From: Mohseni, Aby
Sent: Tuesday, November 24, 2015 1:44 PM
To: Mark Leyse
Cc: Inverso, Tara; Kokajko, Lawrence; Burnell, Scott; Doyle, Daniel
Subject: RE: Fwd: Status of PRM-50-93/95

First) Would you please acknowledge that the NRC's TRACE simulation of FLECHT Run 9573 did **not** predict what cladding temperatures would be at the test bundle's **7 foot elevation** at either 18 seconds or 18.2 seconds?

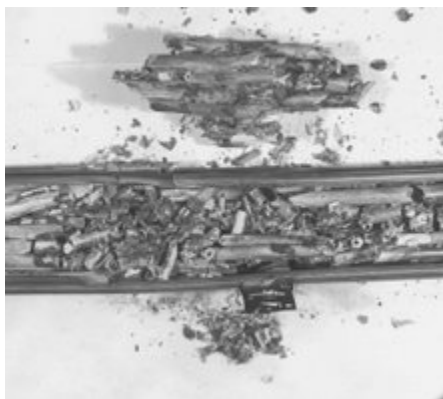
With all due respect, Mr. Mohseni, I do not understand why you answered one of my questions, yet not the other. The unanswered question is simple and pertinent to work the NRC has already completed for its draft interim review.

First) Would you please acknowledge that the NRC's TRACE simulation of FLECHT Run 9573 did **not** predict what cladding temperatures would be at the test bundle's **7 foot elevation** at either 18 seconds or 18.2 seconds?

Second) Would you please acknowledge that the NRC's TRACE simulation of FLECHT Run 9573 did **not** predict what steam temperatures would be around the test bundle's **7 foot elevation** at either at 16 seconds, 18 seconds, or 18.2 seconds?

An adequate TRACE simulation of Run 9573 would have predicted cladding temperatures for the test bundle's 7 foot elevation at either 18 seconds or 18.2 seconds. Or an adequate TRACE (or another code or a modified version of TRACE) simulation of Run 9573 would have predicted steam temperatures around the test bundle's 7 foot elevation at either 16 seconds, 18 seconds, or 18.2 seconds.

Such a TRACE simulation of Run 9573 could have been compared to the Westinghouse data indicating that thermal runaway occurred around the test bundle's 7 foot elevation.

The severe-damage zone where thermal runaway occurred--within approximately ± 8 inches at the 7 foot elevation.

Your questions and comments have been forwarded to the staff reviewing the petition and will be taken into consideration. We appreciate your patience as the NRC's completes the evaluation of your petitions and the related comments. A full response to your rulemaking requests must wait until the NRC's evaluation is complete; please consider the following information to be preliminary. The staff's review of the completed simulation shows the cladding and steam temperatures at the 7-ft elevation (at 18 seconds) are as follows.

No MWR:	Tcladding = 1446 K	Tsteam = 1313 K
CP:	Tcladding = 1526 K	Tsteam = 1370 K
BJ:	Tcladding = 1561 K	Tsteam = 1397 K
